# ***SERVICE PROCEDURE***

**G-11509  
JUNE 2011**

**SUBJECT: SAFETY RECALL  
BATTERY CABLES on certain DuraStar models  
built 1/21/10 thru 4/19/11 with engine feature code  
12UXJ or 12UXH.**

1. Low Pressure Charge Air Cooler
2. Upper Battery Cable Routing Saddle
3. Lower Battery Cable Routing Saddle

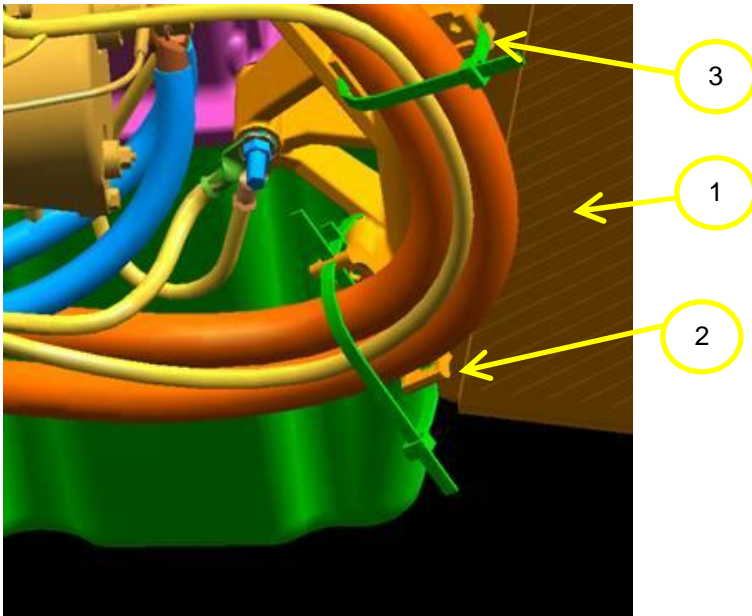
The battery cable insulation may wear on the front suspension spring shackle possibly resulting in an electrical short.

2. Locate the two battery cable routing saddles on the low pressure charge air cooler. Cut the tie straps to free the battery cables.

1. New Battery Cable Routing Bracket

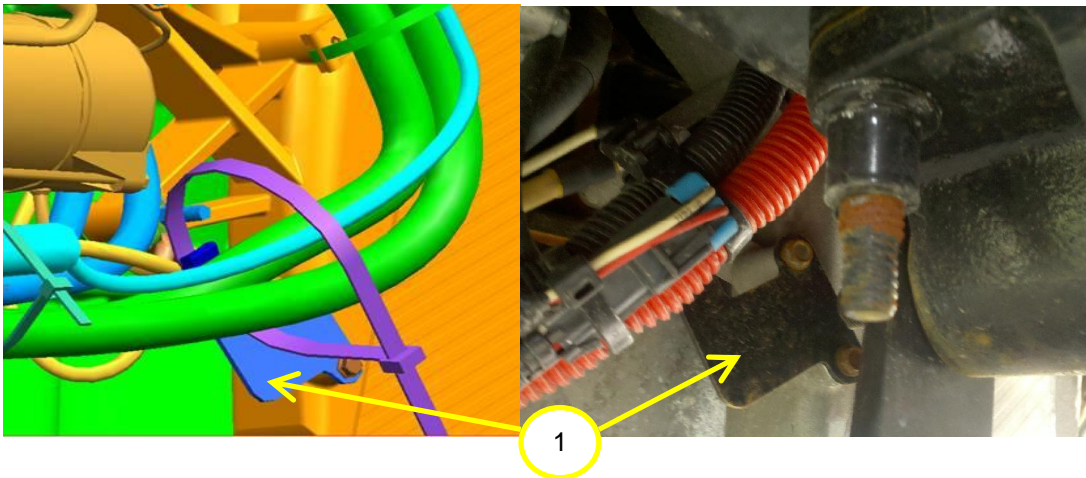
3. Remove the lower battery cable routing saddle and install the new routing bracket.

4. Route the battery cables away from the front spring shackle using the new bracket and existing top saddle. Other battery cable clip points may need to be loosened or cut. Note: any removed tie strap should be replaced with the same size and part number strap. Ensure that the battery cables do not contact anything other than the clip point hardware. Tighten or tie strap the clip points securely.
